PLAN COMMISSION

March 10, 2020

Proposal: Master Landscape Plan Review – Creekside Crossing Marketplace

Proposal: Landscape Plan Review – Stand Rock Hospitality

Buffer Yards:

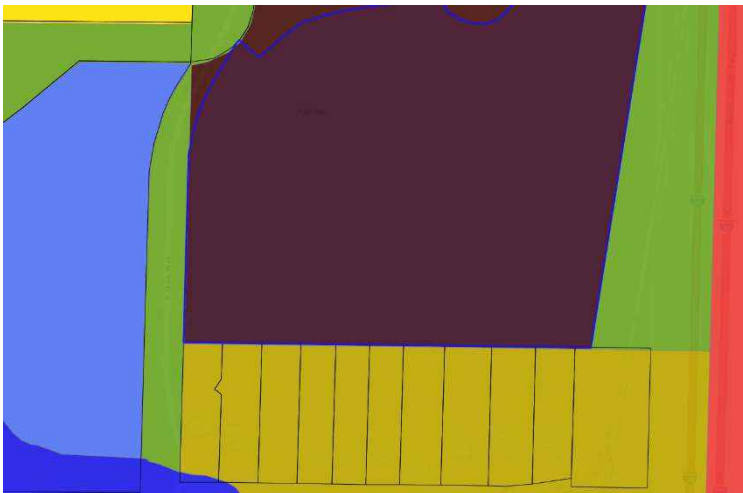
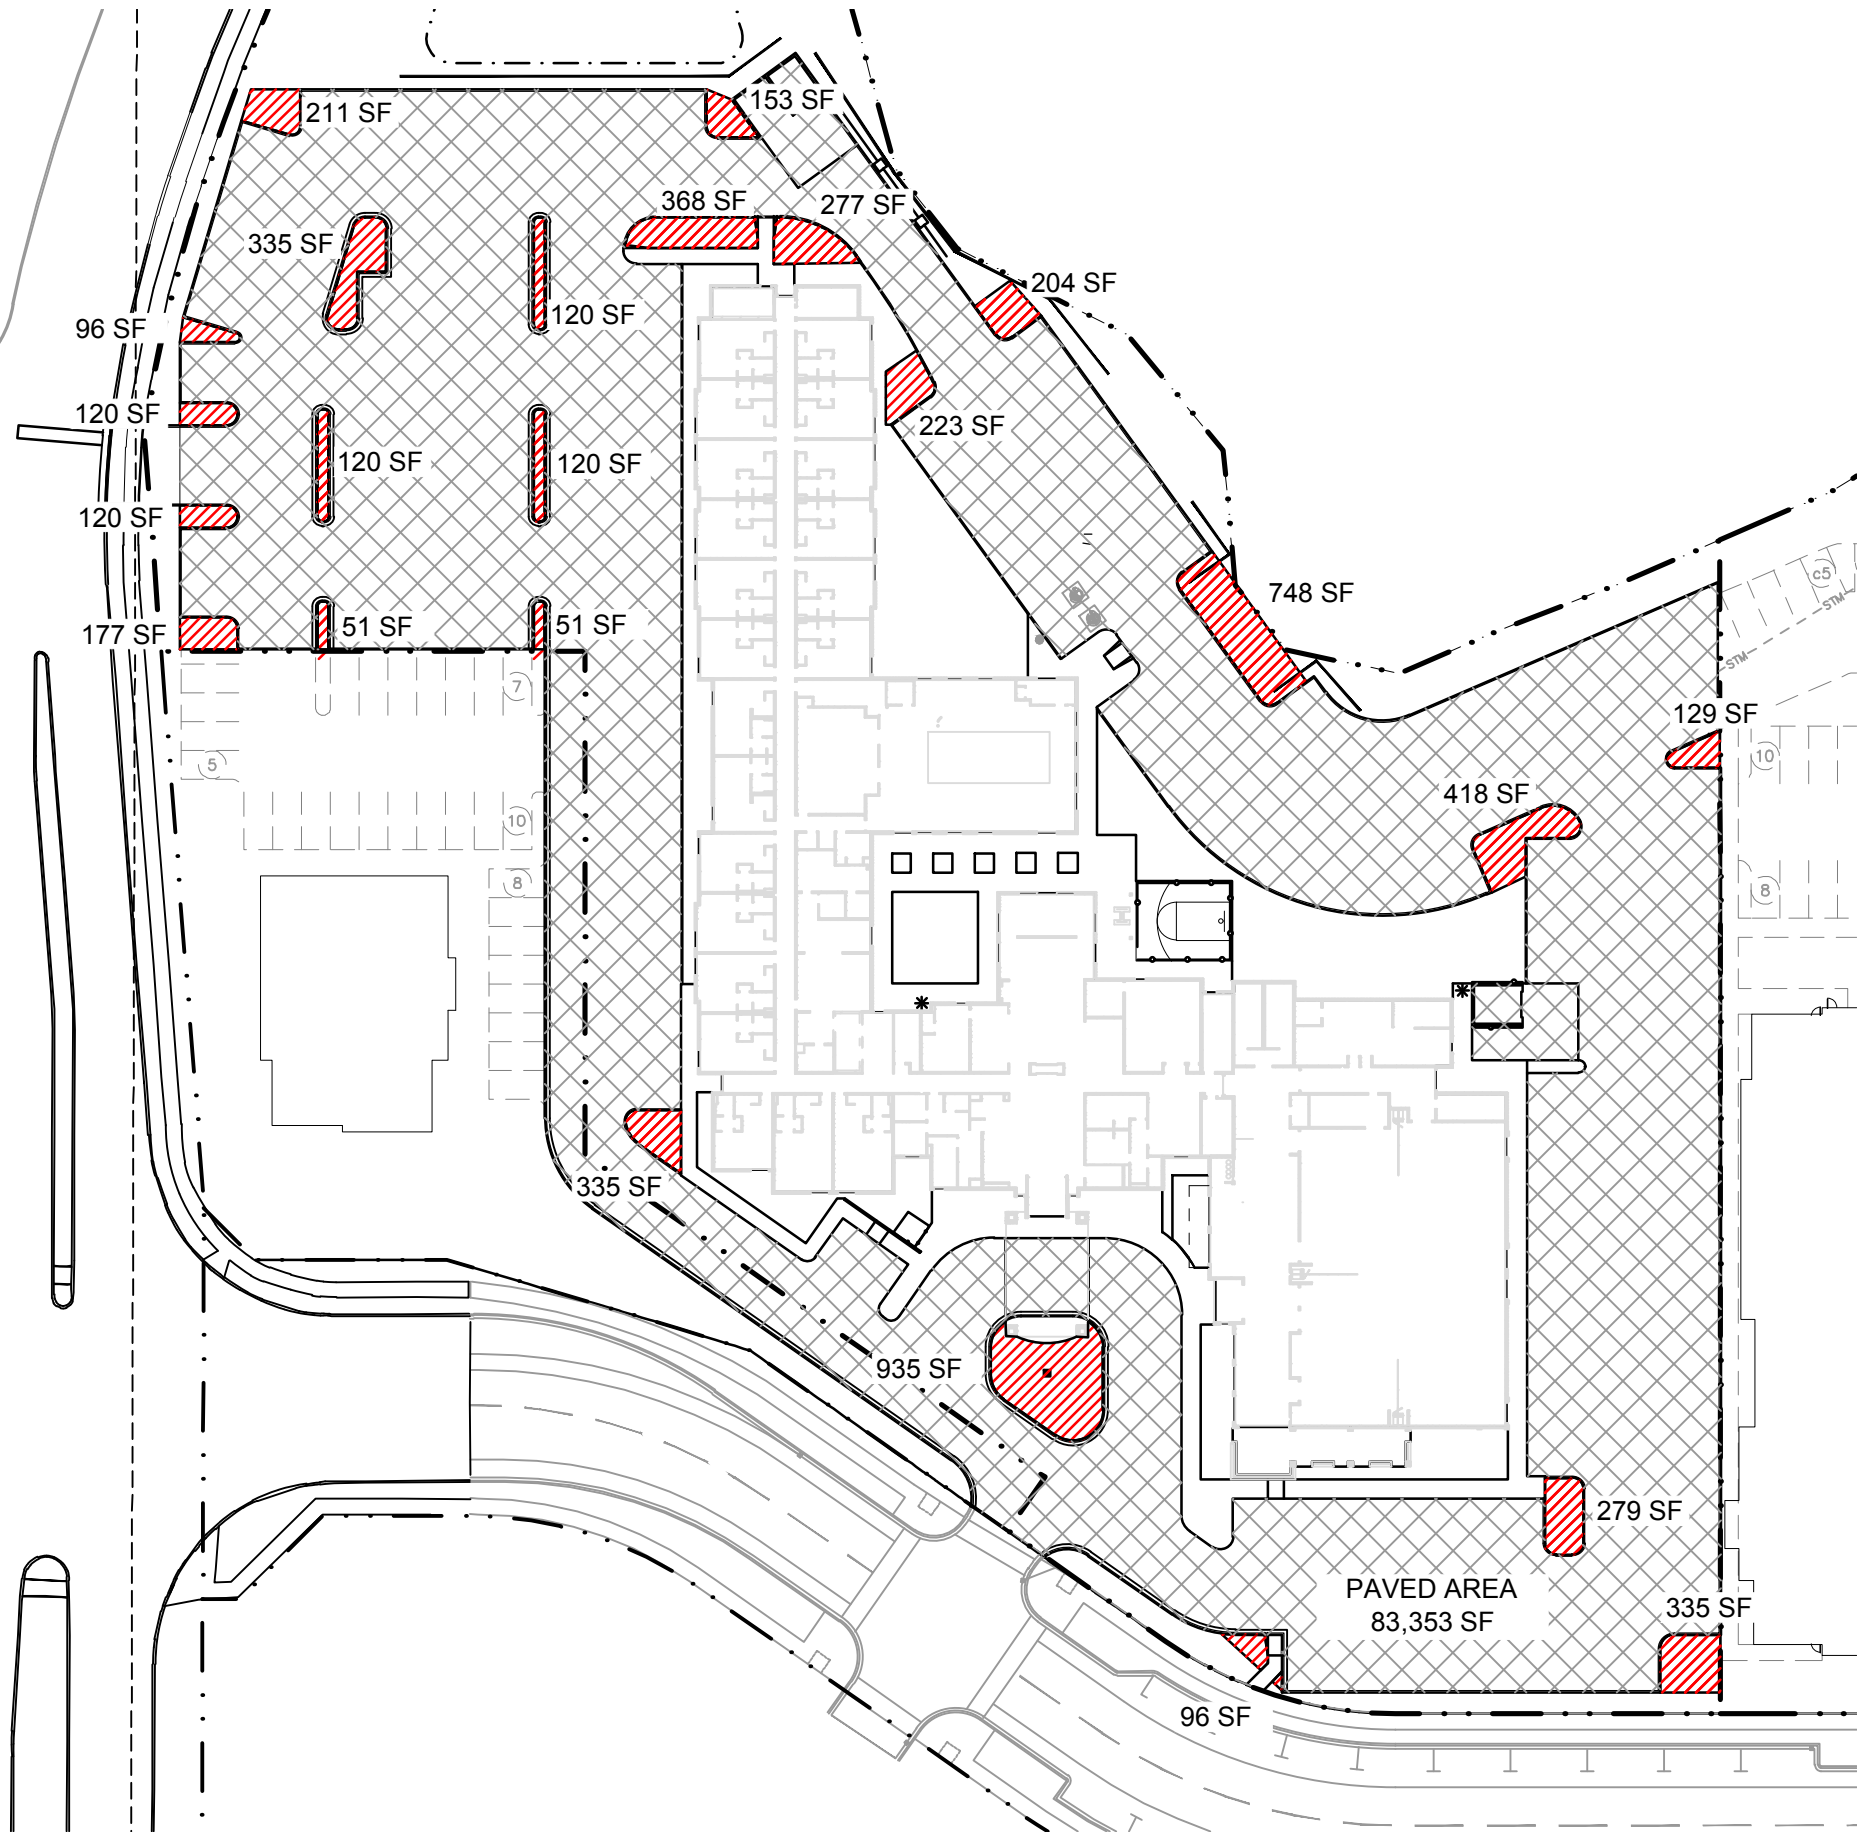
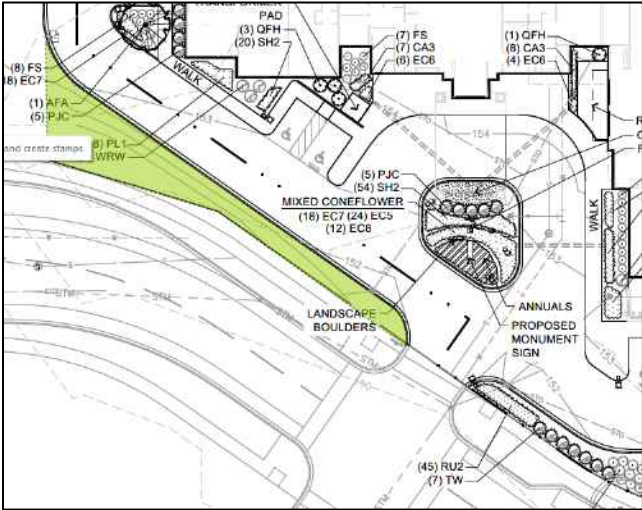
- perimeter landscape strip (minimum average 5 feet in width) required adjacent to parking lot
 - *The strip is not 5 feet wide everywhere, but on average it exceeds 5 feet in width.*
- A minimum of five native plantings are required for every 35 linear feet and one tree for every 80 linear feet
 - *This requirement has not been met. There is native meadow seeding along the north and east sides of the parking lot, but there are not enough trees and no native plantings other than the native seeding.*

- A buffer yard shall be created and maintained in accordance with Municipal Code Section 17.031(6)(l)(1)(m) where the Creekside Crossing Marketplace PUD abuts park districts. No buffer yard shall be required where the Creekside Crossing Marketplace PUD abuts residential districts.

Please work with the Developer to prepare and execute a landscape plan for that portion of Lot 1 adjacent to your property and Creekside Crossing Circle (highlighted in green) to be installed prior to occupancyⁱ.
